DUKE POWER COMPANY

October 17, 1984

Re: Catawba Nuclear Station
Docket Nos. 50-413 and 50-414

CATAWBA NUCLEAR STATION
DEVIATIONS FROM GENERIC EMERGENCY RESPONSE GUIDELINES

Figure 4.9-1. RVLIS System

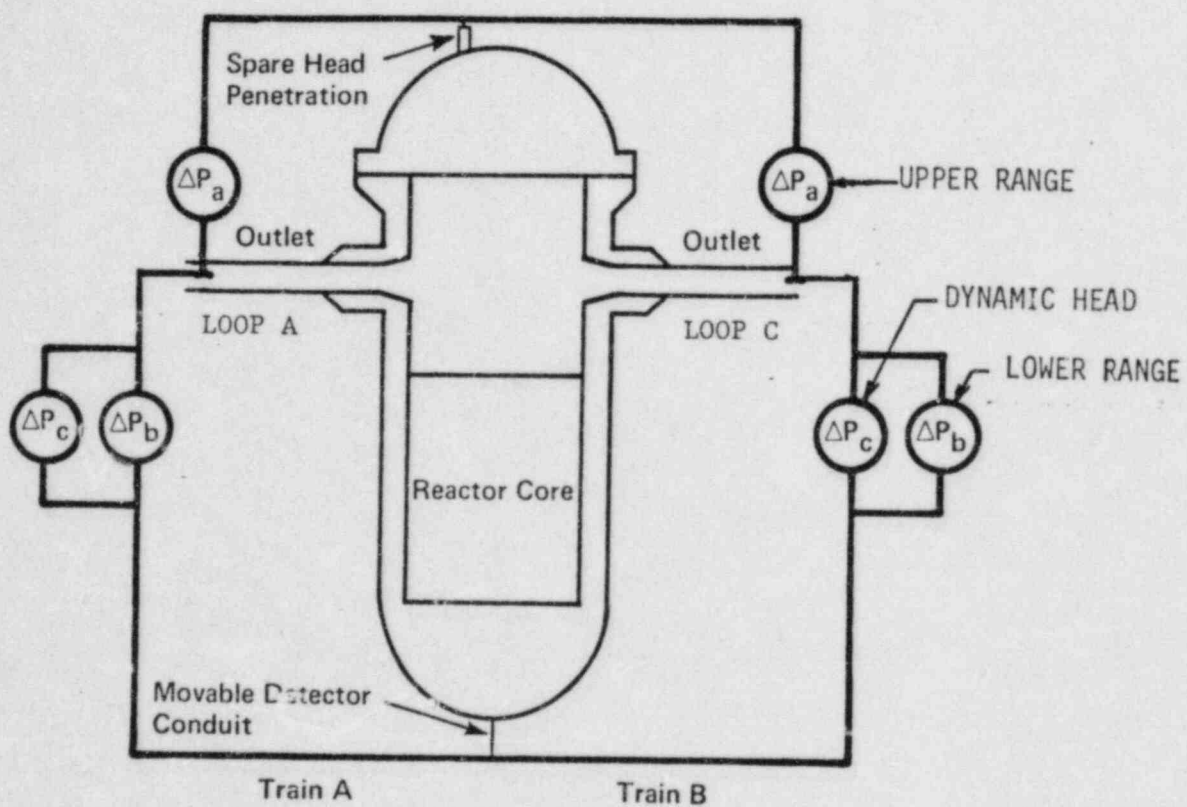
NRC CONCERN

THE RVLIS UPPER RANGE IS NOT USED IF ANY REACTOR COOLANT PUMPS ARE RUNNING, ALTHOUGH SOME CAPABILITY TO DO SO EXISTS.

BASIS FOR NOT USING RVLIS UR WITH RCPS ON

- THE RVLIS CHANNEL IS NOT VALID IF THE RCP IS ON IN THE LOOP WITH THE RVLIS TAP
 - CHANNEL A NOT VALID IF RCP A IS ON
 - CHANNEL B NOT VALID IF RCP C IS ON

- THE UR INDICATION VARIES DEPENDING ON THE NUMBER OF RCPS RUNNING AND TO SOME EXTENT ON THE COMBINATION OF PUMPS RUNNING
- THE DEPENDENCY OF THE RVLIS INDICATION ON THE RCP STATUS SIGNIFICANTLY COMPLICATES THE USE OF IT, IN PARTICULAR IN TERMS OF HUMAN FACTORS. THE USE OF THE RVLIS DHR ALSO DEPENDS ON THE RCP STATUS - HOWEVER ITS USE IN THAT MODE IS NECESSARY FOR ICC MITIGATION. (SEE NEXT PAGE)

- IT IS UNLIKELY THAT A PLANT TRANSIENT WILL EVOLVE INTO THE CONDITIONS OF CONCERN, I.E. RCPS RUNNING WITH A LARGE NONCONDENSIBLE VOID. THIS WOULD ONLY OCCUR DUE TO AN ICC EVENT. THE EPGS WILL NOT RESTART A REACTOR COOLANT PUMP IF A VESSEL HEAD VOID IS NONCONDENSIBLE. THE VOID IN THAT CASE WOULD BE VENTED PRIOR TO RCP RESTART.

- FOLLOWING AN ICC EVENT THE HEAD VOID WOULD NOT BE VENTED WITHOUT CONCURRENCE FROM THE TSC. UTILIZATION OF THE UR WITH RCPS ON COULD BE CONSIDERED AT THAT TIME

- LOW OPERATOR CONFIDENCE
- LITTLE OPERATIONAL EXPERIENCE WILL BE GAINED IN THE AREAS OF INTEREST
- THE EXISTING METHOD PROVIDES ALREADY FOR A LEVEL OR VOID FRACTION INDICATION UNDER ANY CONDITIONS
